Item 4.**Development Application: 4-22 Wentworth Avenue, Surry Hills - D/2025/942****File Number: D/2025/942****Summary**

Date of Submission:	3 October 2025 Amended plans and information submitted 15 February, 6 March and 1 April 2026
Applicant:	Wentworth Avenue Surry Hills Development Pty Ltd
Architect:	DKO and Aileen Sage
Developer:	Willow Development Group
Owner:	Pongrass Properties Pty Ltd
Planning Consultant:	Planning & Co
Heritage Consultant:	Jean Rice Architect
DAP	4 December 2025
Cost of Works:	\$71,915,857.20
Zoning:	The site is zoned MU1 - Mixed Use under the Sydney Local Environmental Plan (Sydney LEP) 2012. The proposed uses are commercial office and ancillary retail premises, which are permissible with consent in this zone.

Proposal Summary:

Figure 27: Axonometric view of proposal, with DCP envelope and envelope exceedances indicated

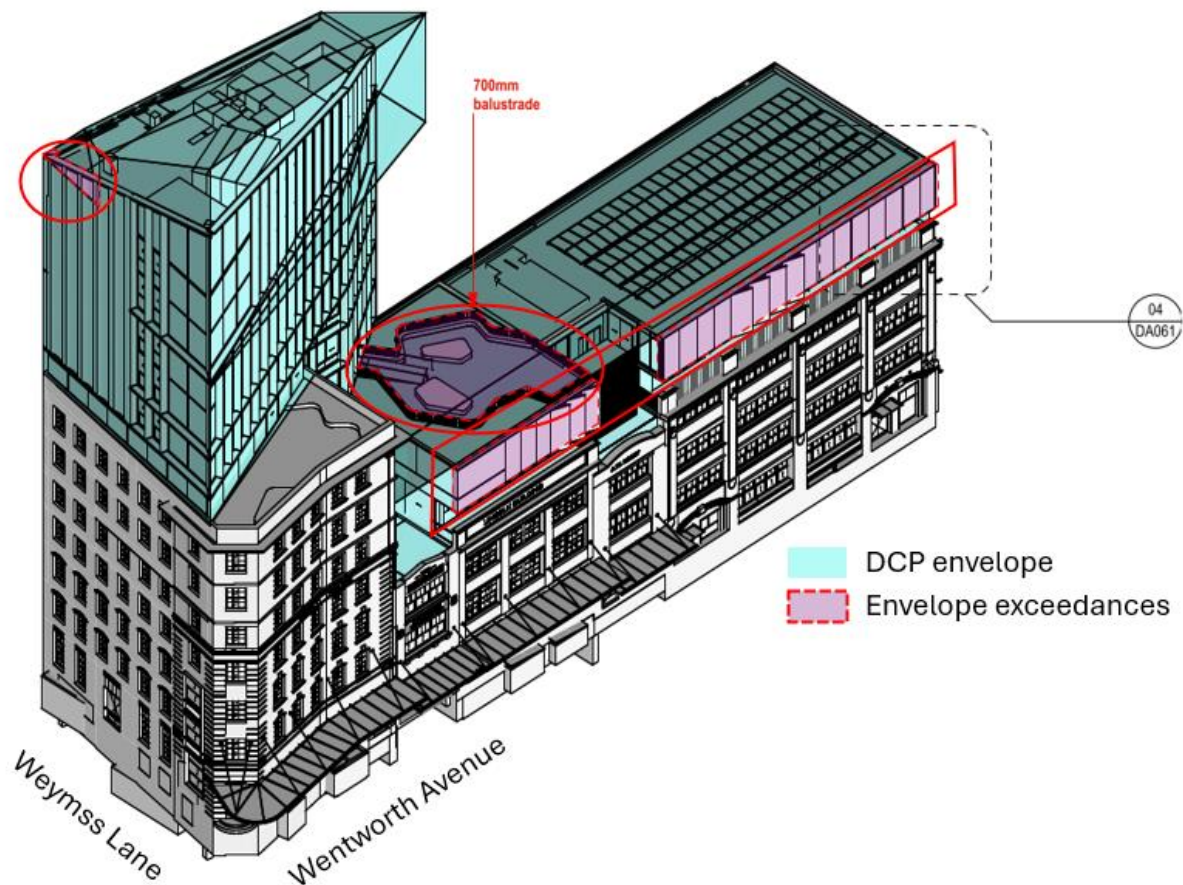
59. The proposal seeks to utilise the additional built for the podium but does not occupy the cantilevered portion of the tower (see Figure 27 below). The proposal also contains minor exceedances, related to fenestration/facade thickness across the tower (north-east corner) and the podium addition (west elevation), and a rooftop balustrade contained within the podium addition.

60. The exceedances range from 500mm in depth (the Wentworth Avenue facade) to the 700mm high balustrade above 10-12 Wentworth Avenue. These projections are largely devoid of gross floor area. These projections do not breach the maximum height development standard contained in Clause 6.55 of the Sydney LEP 2012, with the balustrade above 10-12 Wentworth Avenue being excluded from the measurement of building height. The minor exceedances have minimal impact on overshadowing, given their location. See overshadowing discussion below.

Figure 33: Proposed photomontage of the tower addition, depicting the large picture windows and vertical fins (left) and level 10 floor plan of the tower with fins outlined in red to be increased in depth to provide shading

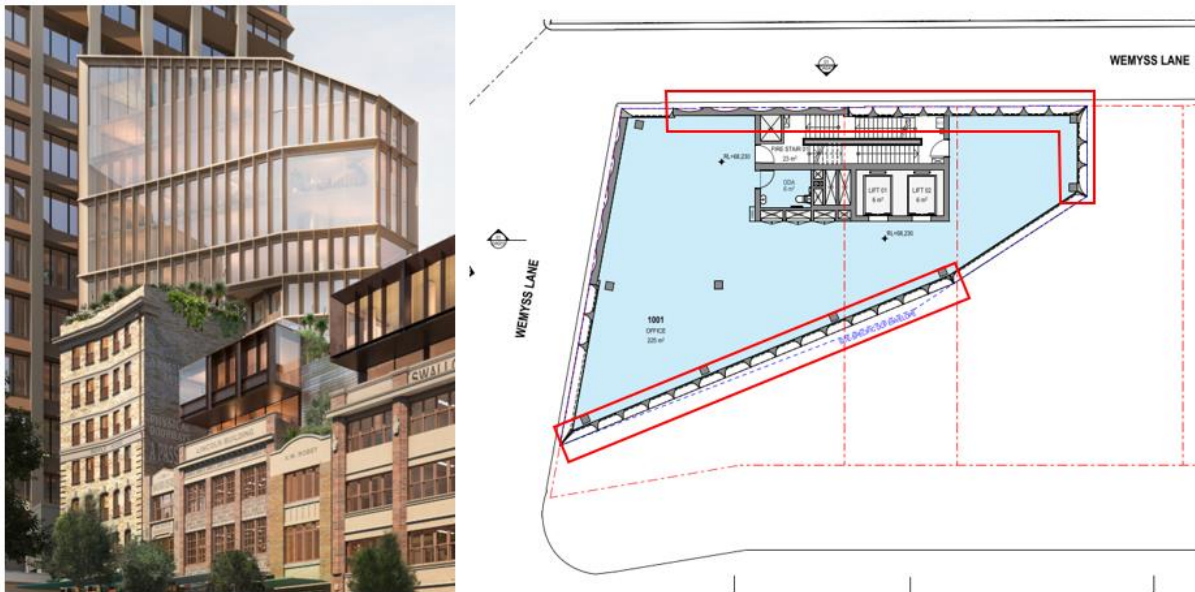
Panel Recommendation	Response
The large panes of glass on the western and southern facades of the tower pose sustainability and reflectivity issues. Fine detailing on the large panes, consistent with the concept, is recommended to improve solar protection and reduce reflectivity.	The proposal has not addressed the DAP's recommendation and no additional fine grained passive solar shading to the large areas of glass that faces the west and south-west facade. The proposal, rather, relies largely on the high performance of the glazing, with a reflectivity report confirming that the development will meet the 20% reflective facade requirement of the DCP.

Panel Recommendation	Response
	Noting that the building expression is very similar to that which won the design competition, it is recommended that the vertical fins across the tower facade be extended in depth to 450mm to provide solar shading, with the larger 'picture' to have their own design for external solar shading and glare control which may incorporate triple glazing. The extension of the fins will sit outside of the DCP envelope in some parts, but this is acceptable noting that these are minor architectural elements. See Figure 33 below, outlining fins to be conditioned. An appropriate condition is included in Attachment A.
Generally, the Panel recommends maximising passive energy measures to minimise energy consumption.	The application proposes the installation of solar PV cells above the podium addition and has committed to a 5.5-star NABERS Energy rating.
The Panel supports the proposition and form of the two floating podium elements. However, they appear to be excessively bland and do not have a strong relationship with the heritage buildings below. Further refinement is recommended for light and playful podium elements that respond to the rhythm of the buildings below.	The podium addition has been amended so that the vertical rhythm of the host buildings is expressed as vertical fins, aligning with the different proportions of 10-12 and 16-22 Wentworth Avenue. This, along with the bronze powder-coated framing of the additions provide more consistency across the two podium elements. Within this framework the 'playfulness' is expressed with different fenestration and the northern-most module (above 10-12) being expressed as a glass box. It is recommended that the bays above 10-12 Wentworth Avenue be redesigned to align more appropriately with the DAP's advice. See image and further discussion below.

76. To provide more consistency between the 3 bays above 10-12 Wentworth Avenue, whilst still achieving the light and playful expression that the DAP is seeking, it is recommended that all 3 bays have a consistent architectural expression rather than the single glass box. An appropriate condition is recommended. Refer to Attachment A.
77. The amended proposal, subject to conditions requiring minor refinement of the facades, is considered to have satisfactorily addressed comments and concerns raised by the Selection Panel and DAP as outlined above and retains to the design integrity and key aspects of the winning scheme. The proposal satisfies the provisions of clause 6.21D of the Sydney LEP 2012 and accordingly is eligible for 10% additional floor space ratio pursuant to subclause 3(b).

Figure 35: Proposed section through 14 Wentworth Avenue, with floors that do not meet the existing facade circled in red

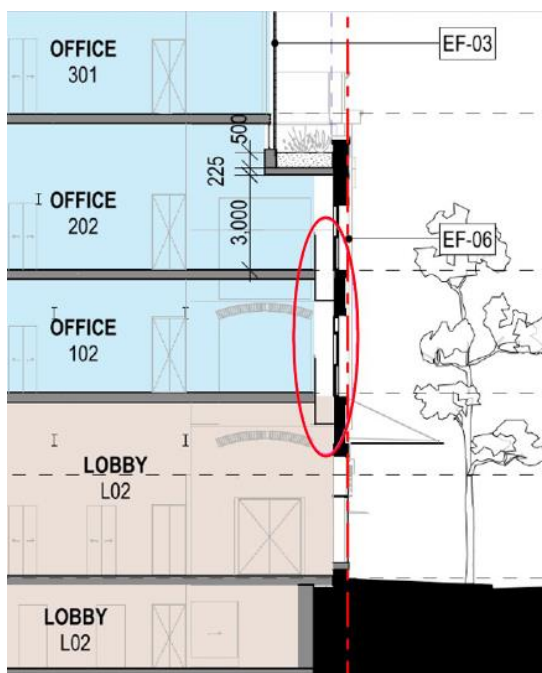
92. Number 14 Wentworth Avenue is to contain new floors that do not meet the existing facade, however there is no information provided on the fire engineering solution. See the affected junctions below, circled in red:

93. The fire engineering solution will need to be determined prior to construction being carried out, to ensure that the impact to the ground level heritage fabric and shopfronts is minimised. A condition is recommended for any works to comply with the National Construction Code, whilst also minimising damage to existing fabric and heritage features. If any upgrading works to address the fire engineering solution are required, details are to be submitted to Council for approval prior to the issue of any Construction Certificate. An appropriate condition is recommended in Attachment A.

Figure 36: Proposed section through warehouse podium addition. Louvres are indicated by red dashed lines.

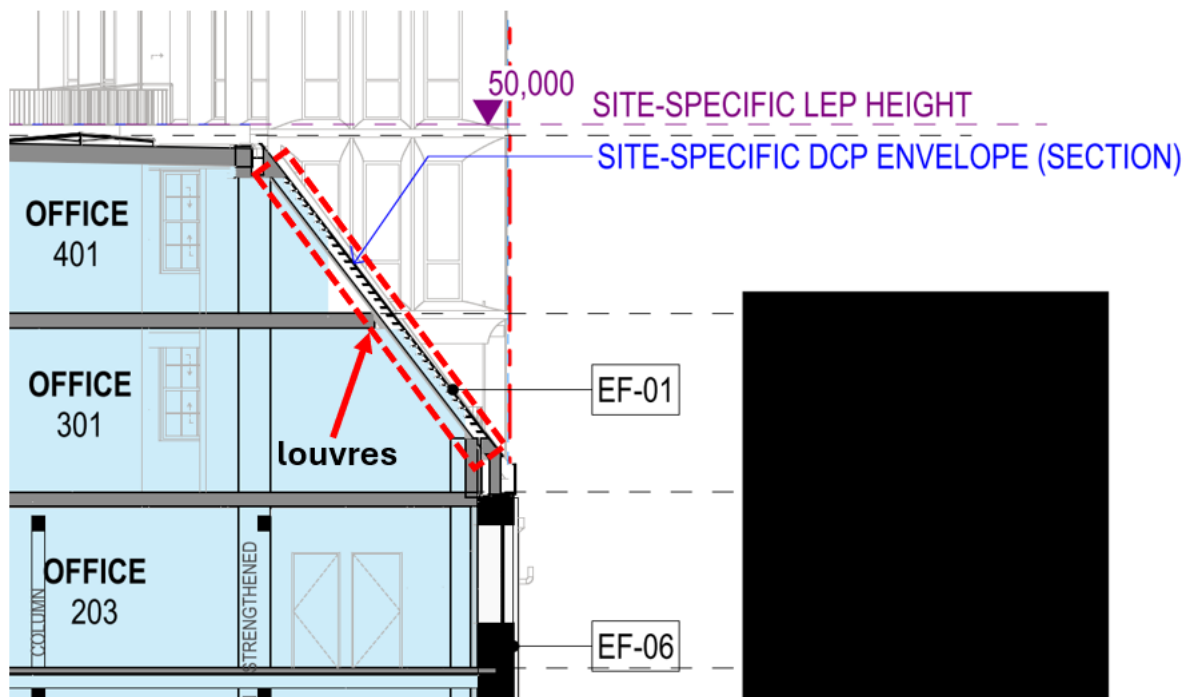
- (b) Levels 3 and 4 are contained within an angled roof to the Weymss Lane elevation. The roof has a nil setback at the floor level 3, however this increases up to 9.4m at the top. The sloping of the roof limits the usability of the area behind. It is noted that in section and elevation, the roof has been designed with louvres to limit privacy impacts to the apartment building, but this has been left off the material schedule. A condition is recommended to ensure the louvres are installed and angled so that direct sightlines to the apartment building are limited. See Figure 36 below.

Response: The proposal is considered to have satisfactorily addressed privacy impacts, as discussed within this report. A condition is recommended to confirm that louvres are to be installed to the Weymss Lane elevation of the podium addition.

Figure 37: Proposed level 5 plan. Separation distances between Meta Apartments and the tower are indicated.

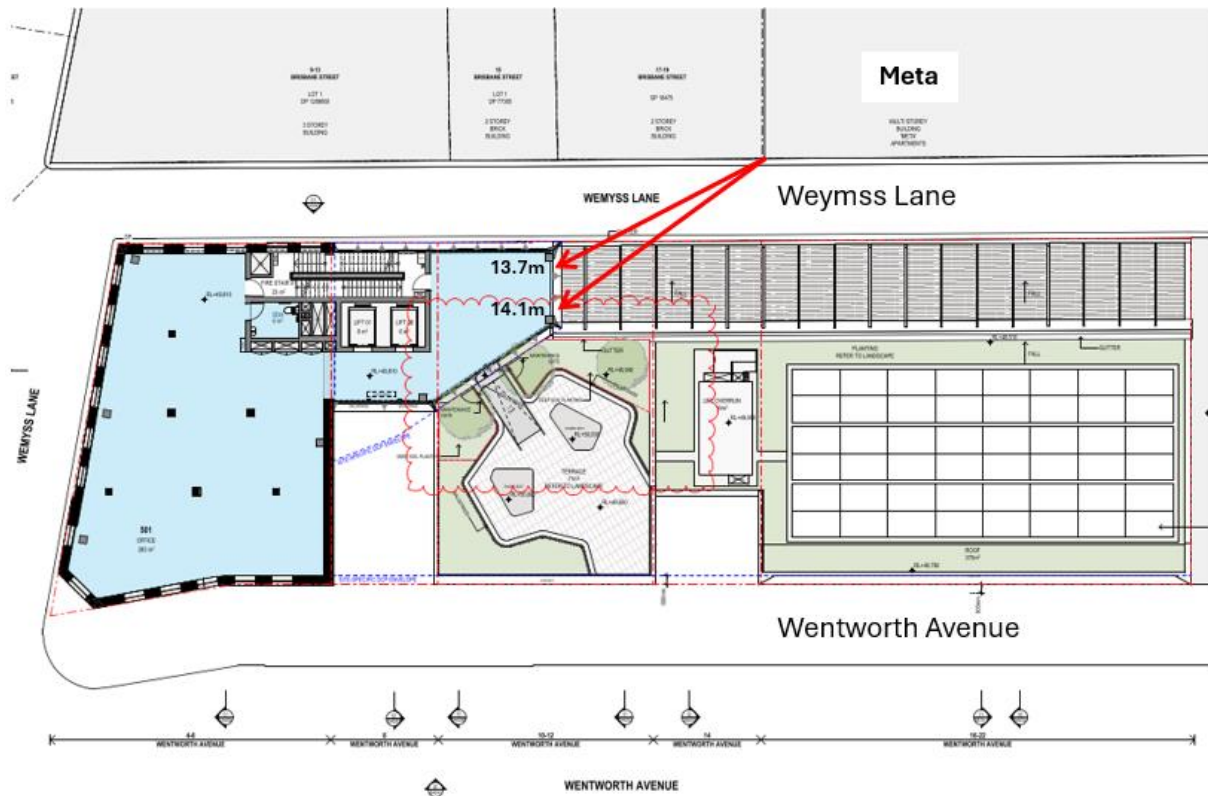
- (d) The tower has been designed so that the faceted corner (south elevation) contains vertical fins at levels 5-7, limiting views out towards 21 Brisbane Street, which is approximately 13.7m away. Levels 8 and above sit higher than the residential apartment building, with little to no direct views. The separation distances in this location comply with the ADG. See level 5 plan below (levels 6-7 and similar for tower separation).
